**D'ANDREA SURVEYING &
ENGINEERING, P.C.**

June 11, 2021

Re: "Commercial Development"
Hope Street, LLC
523 & 535 Hope Street
Stamford, CT
Zoning Application No. 221-17

The following responses correspond respectively to the comments listed in your review memorandum to Vineeta Mathur, dated May 3, 2021.

REV.	DATE	DESCRIPTION	1	6-11-21	ZONING RESUBMISSION	0	4-15-21	ZONING SUBMISSION
REV.	DATE	DESCRIPTION								
1	6-11-21	ZONING RESUBMISSION								
0	4-15-21	ZONING SUBMISSION								
LOCATION	535 & 523 HOPE STREET STAMFORD, CONNECTICUT									
2 OF 6	SITE GRADING AND LAYOUT PLAN

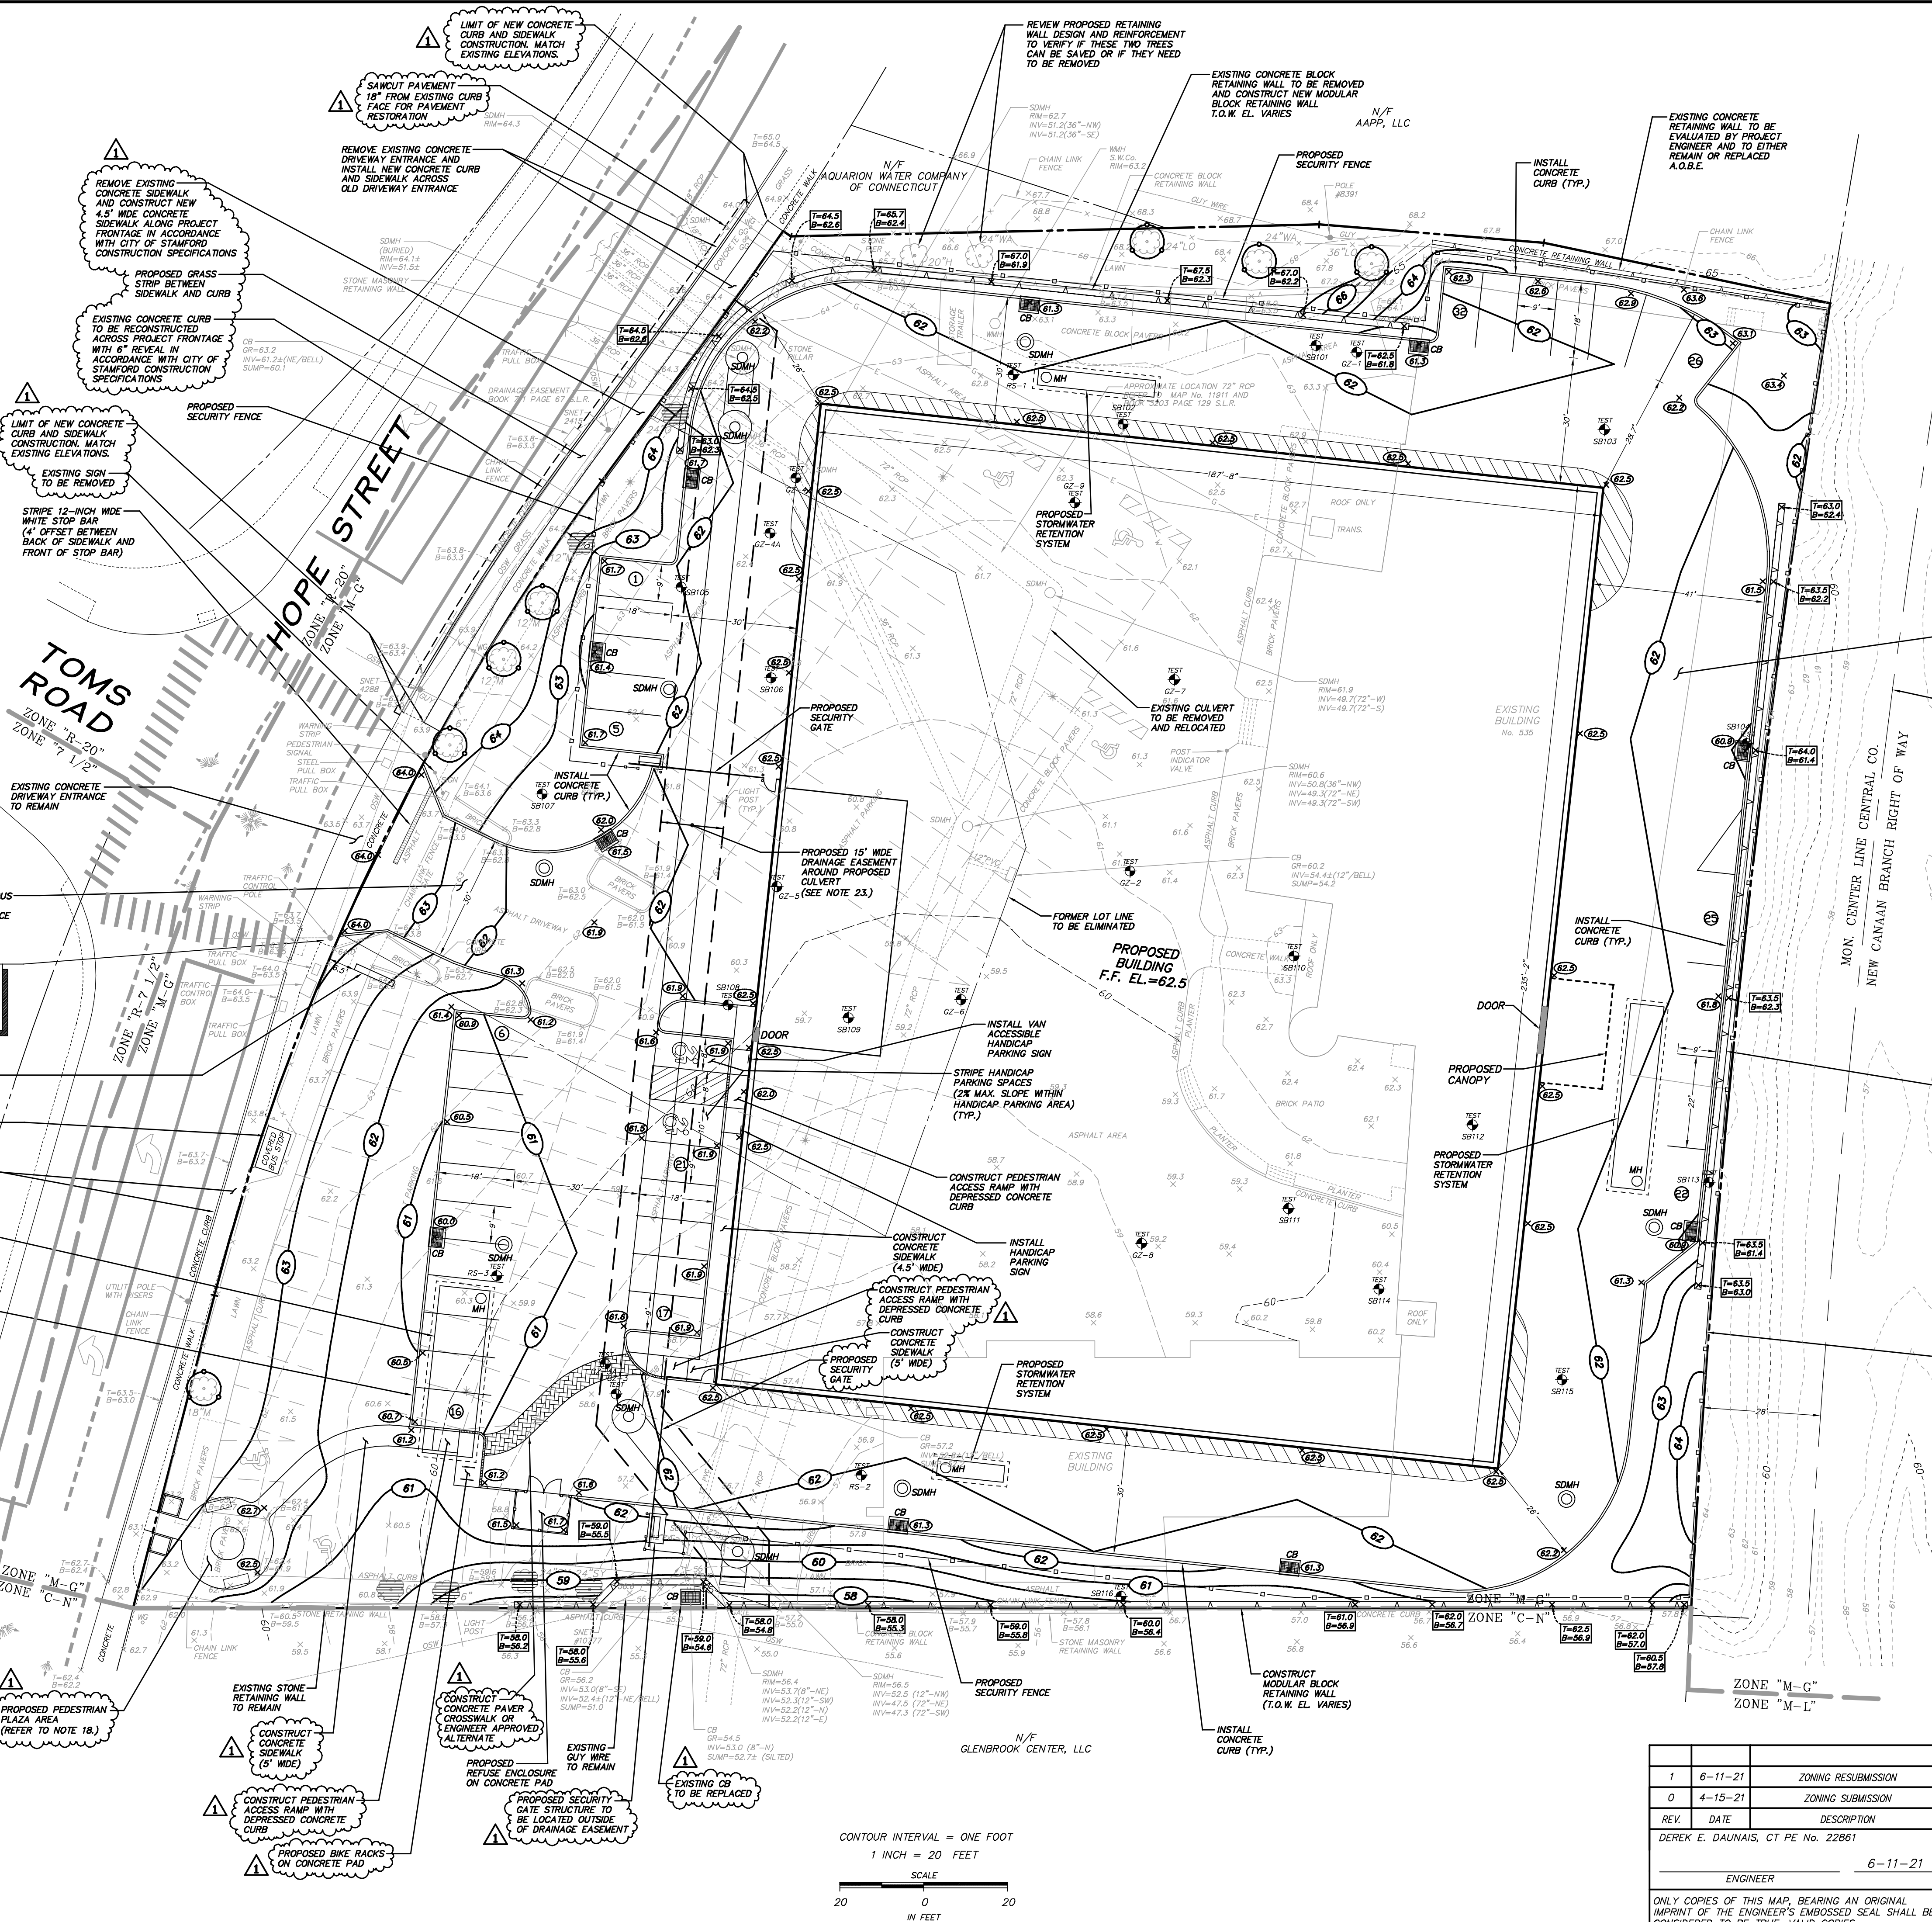
1. The proposed grading contour labels in the southwest corner of the property have been corrected. Refer to Sheet 2 of 6.
2. The proposed grading along the southerly property line has been reviewed and found to be acceptable.

7. A lot consolidation map will be filed on the Stamford Land Records prior to the issuance of a Building Permit.
8. The proposed security gate near the southwest corner of the building has been shifted to the west, so that its southerly base structure will now be outside of the proposed drainage easement. Refer to Sheet 2 of 6.

13. The entire concrete curb and sidewalk along Hope Street north of the existing driveway entrance to remain up to the northern property line has now been called out to be replaced. Refer to Sheet 2 of 6. Refer to Sheet 5 of 6 for concrete curb and sidewalk details.

PROJECT	COMMERCIAL DEVELOPMENT
PREPARED FOR	HOPE STREET, LLC
LOCATION	535 & 523 HOPE STREET STAMFORD, CONNECTICUT
3 OF 6	STORM DRAINAGE AND UTILITY PLAN

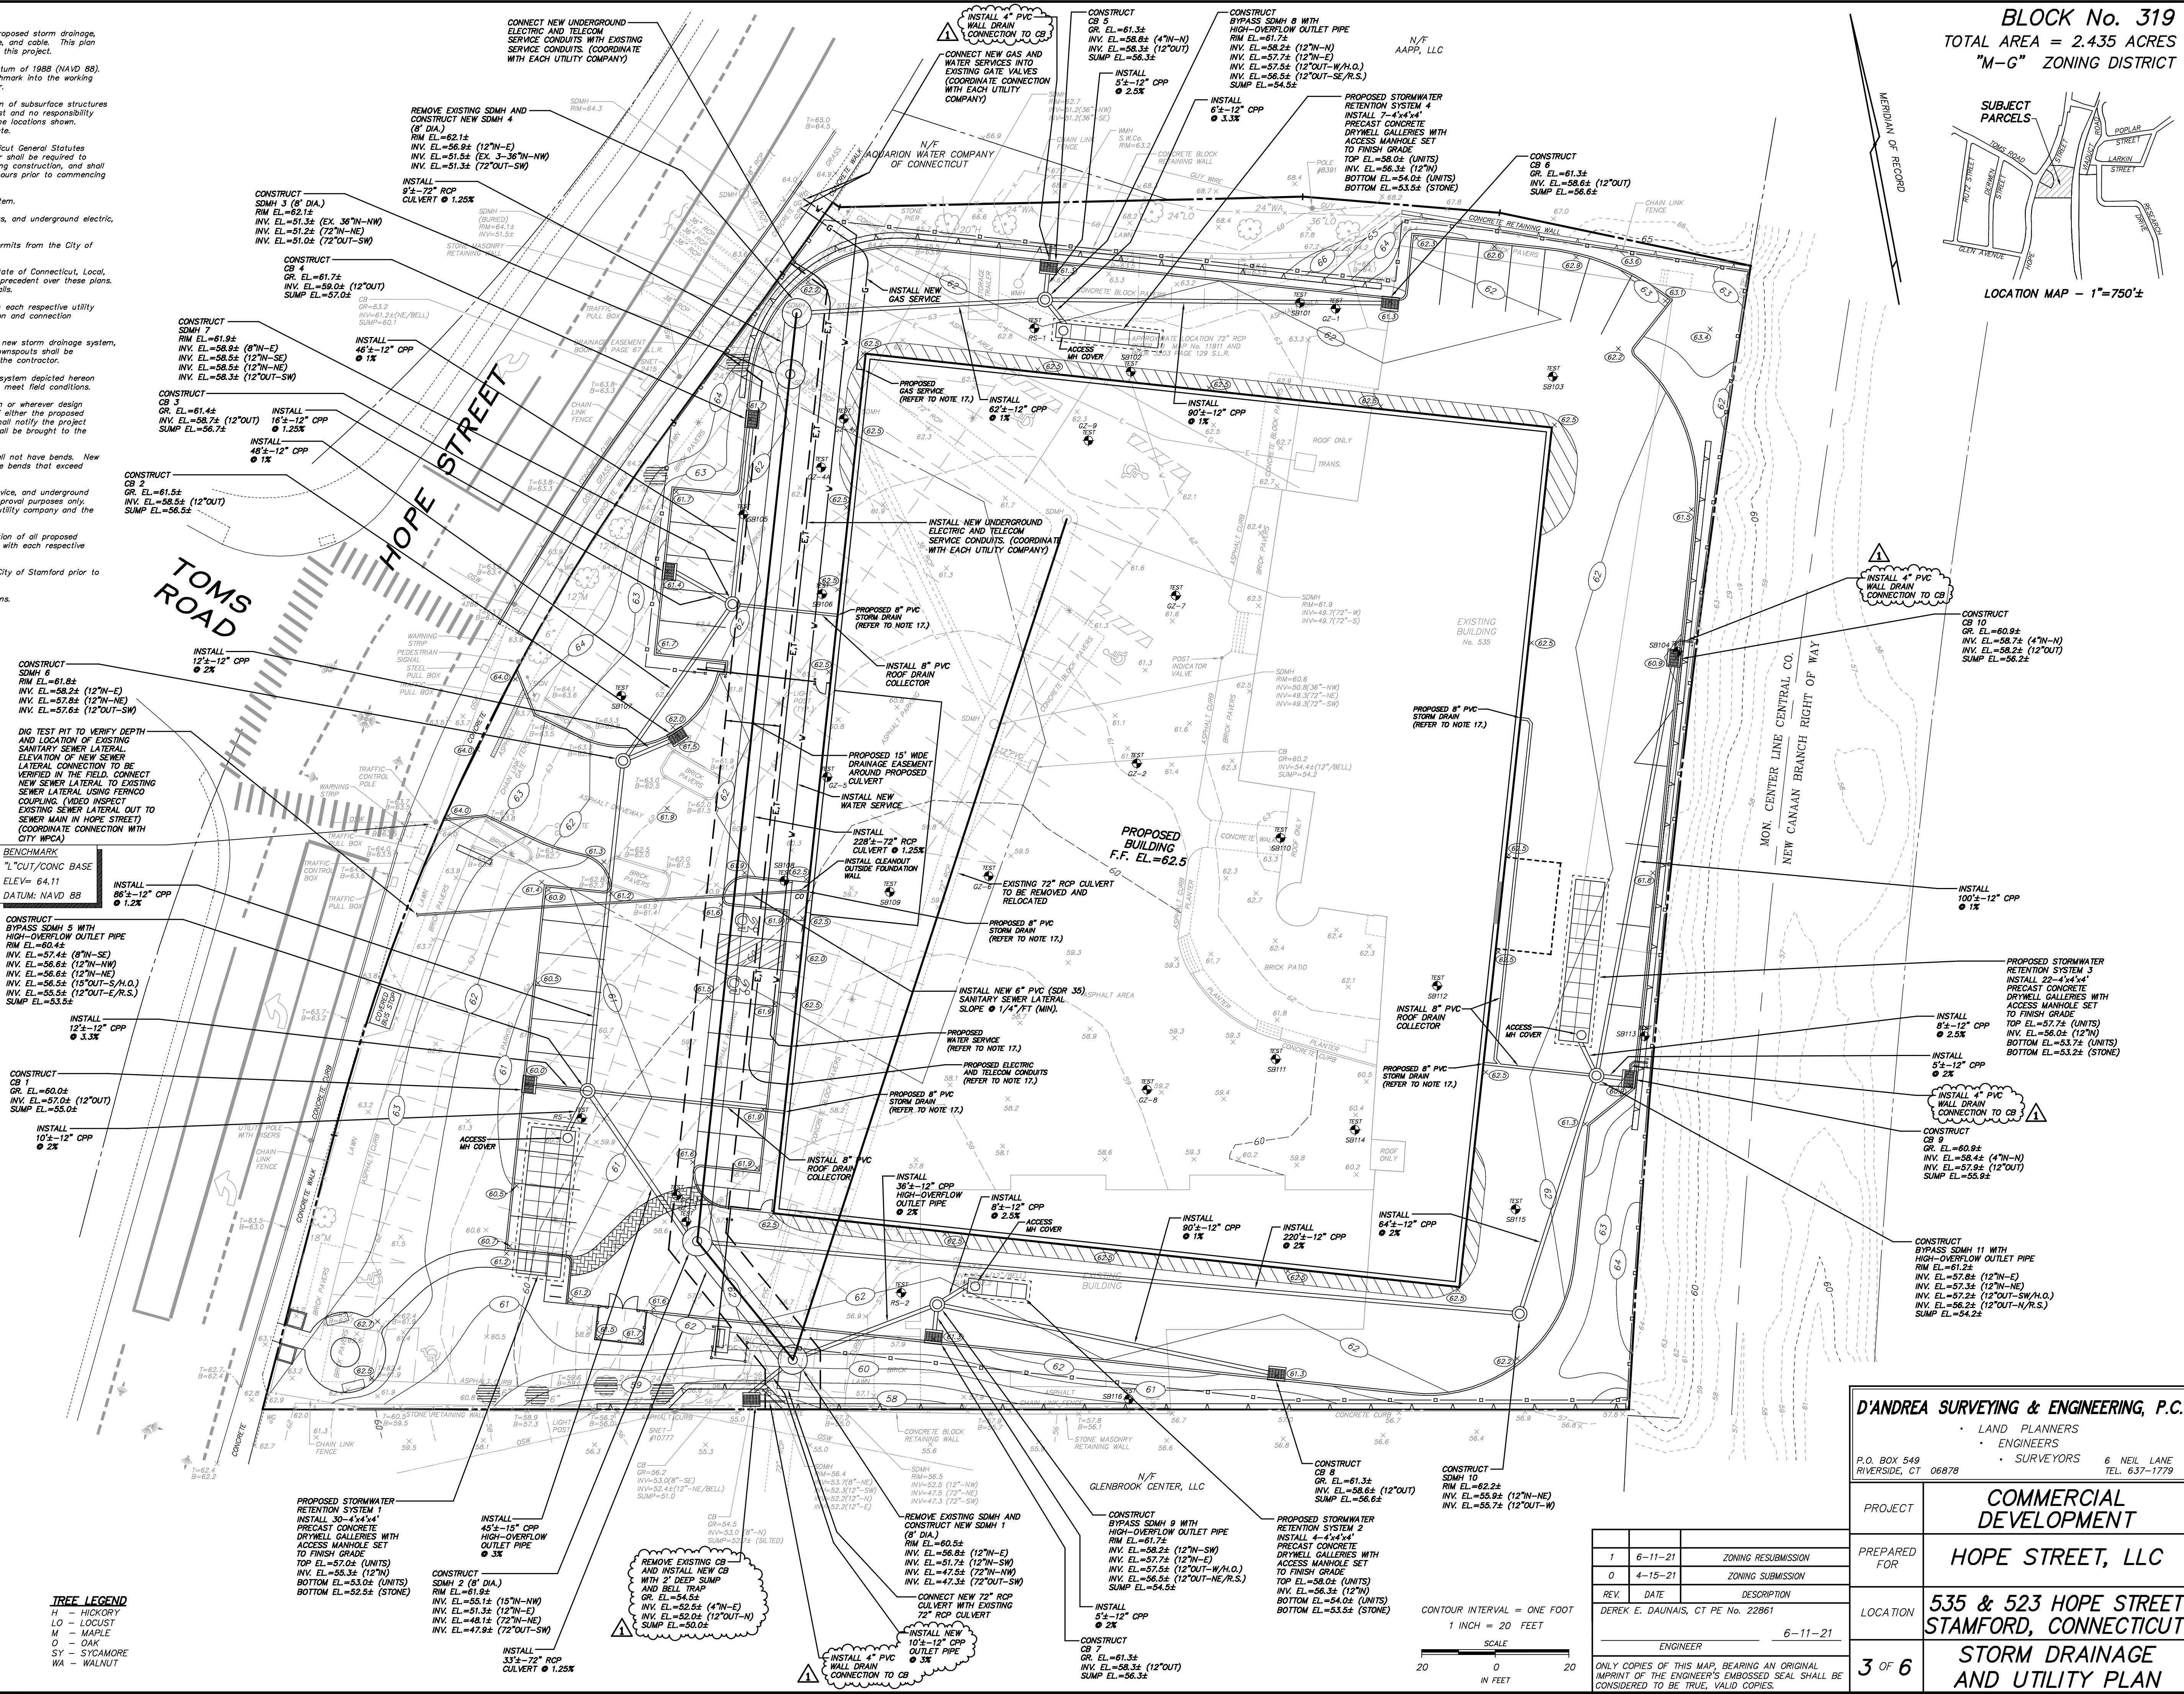
4. There is no basement proposed for the building and therefore there are currently no underdrains being proposed for this project.
5. The existing catch basin along the southerly property line has been called out on Sheet 3 of 6 to be replaced with a standard 2' sump and bell trap basin.

9. Wall drain outlet connections to nearby catch basin structures have been added to Sheet 3 of 6.
10. The existing building structure has prohibited test borings to be performed in some areas. However, additional deep test borings have been conducted on the property in the vicinity of all proposed subsurface retention/infiltration systems. Refer to Sheet 3 of 6 for additional deep test boring locations.
